[Docket No. FAA-2012-0415; Directorate Identifier 2008-SW-065-AD; Amendment 39-17865; AD 2014-12-04]

**Airworthiness Directives; Bell Helicopter Textron, Inc. (BHTI) Helicopters**

**ACTION:** Final rule.

Figure 1 to Paragraphs (f)(2)(ii) and (f)(4)(ii)  
Inspection of Main Rotor Hub Grip Tangs

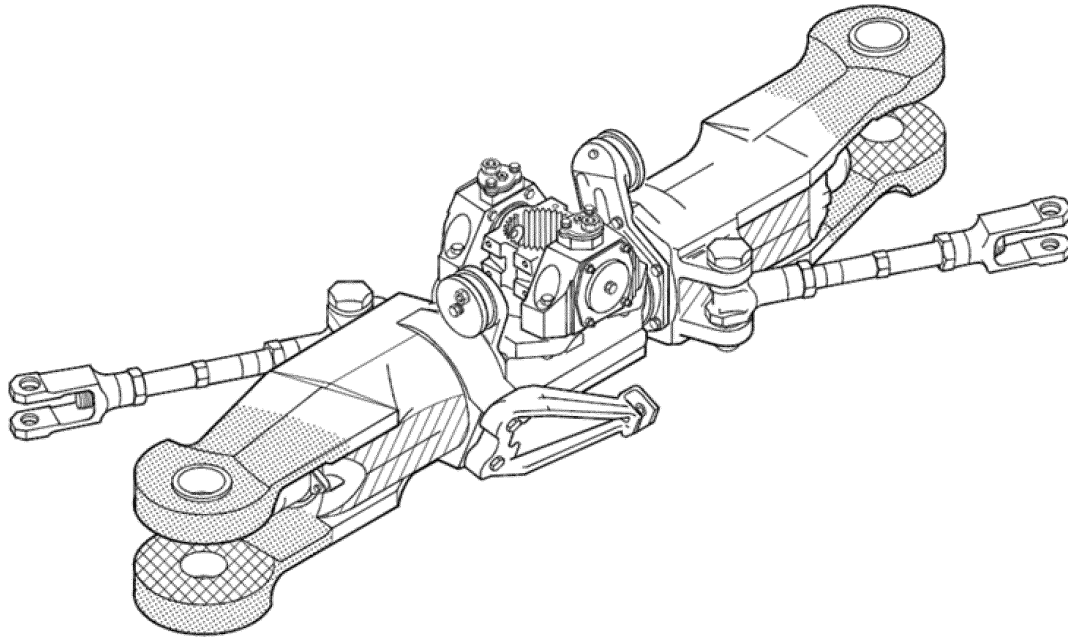
- (ii) Using a 10-power or higher magnifying glass, visually inspect the exposed surfaces of the upper and lower tangs of each grip for a crack. Pay particular attention to the lower surface of each lower grip tang from the main rotor blade bolt-bushing flange to the leading and trailing edge of each grip tang as depicted in Figure 1 to Paragraphs (f)(2)(i) and (f)(4)(ii) of this AD.

(ii) Inspect each grip buffer pad on the inner surfaces of each grip tang for delamination as depicted in Figure 1 to Paragraphs (f)(2)(ii) and (f)(4)(ii) of this AD. If there is any delamination, remove the buffer pad and inspect the grip surface for corrosion or other damage.
